Access Compliance Report

Public Rights-of-Way

Intersection ID: 30275	Main Street: BLYTHEDALE_DR	Cross Street: SMITHTON_LN	Location: E
ADA ID: ECE4AB059752	Ramp Type: PerpDiag	Initial Pass/Fail: Fail	Overall Compliance: No
		Severity Score: 37.5

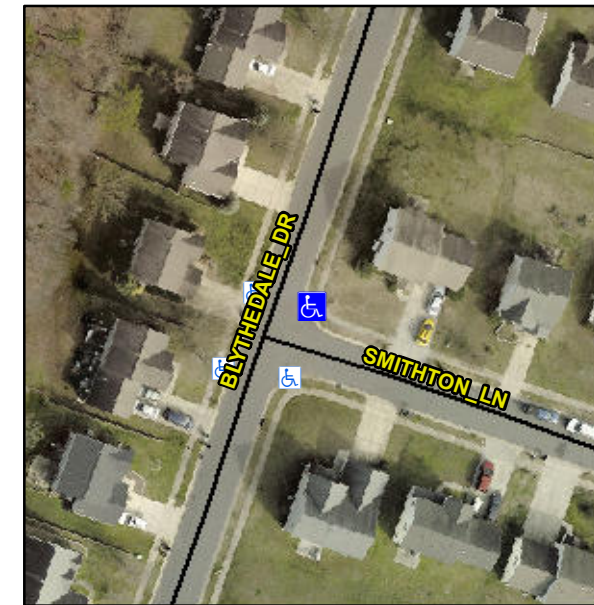
Not Found, R304.2.2, R304.5.3

Compliance	Description	Data	Compliance	Description	Data
N/A	Ramp Length (in)	49.0	No	Ramp Slope (%)	9.7
Yes	Ramp Width (in)	48.0	No	Ramp XSlope (%)	10.9
N/A	Flare Type LT	N/A	N/A	Flare Type RT	N/A
N/A	Flare Slope LT (%)	N/A	N/A	Flare Slope RT (%)	N/A
N/A	Flare Traversable LT?	N/A	N/A	Flare Traversable RT?	N/A
N/A	Landing Length (in)	N/A	N/A	DWS Provided?	N/A
N/A	Landing Width (in)	N/A	N/A	DWS Contrast?	N/A
N/A	Landing Slope (%)	N/A	N/A	DWS Length (in)	N/A
N/A	Landing X Slope (%)	N/A	N/A	DWS Full Width?	N/A
N/A	Landing Curb? (Y/N)	N/A	N/A	DWS Offset (in)	N/A
N/A	Shared Landing?	N/A			
N/A	Gutter Ponding?	N/A	N/A	Gutter Slope (%)	N/A
N/A	Gutter Lip Ht (in)	N/A	N/A	Gutter X Slope (%)	N/A
N/A	Painted X Walk1?	No	N/A	Painted X Walk2?	No
	X Walk 1 Direction	To N		X Walk 2 Direction	To S
N/A	X Walk 1 Width (in)	N/A	N/A	X Walk 2 Width (in)	N/A
	X Walk 1 Slope (%)	3.2		X Walk 2 Slope (%)	4.9
	X Walk 1 X Slope (%)	6.0		X Walk 2 X Slope (%)	5.5

Remove & Replace Curb Ramp With Two New Directional Ramps or Equivalent.
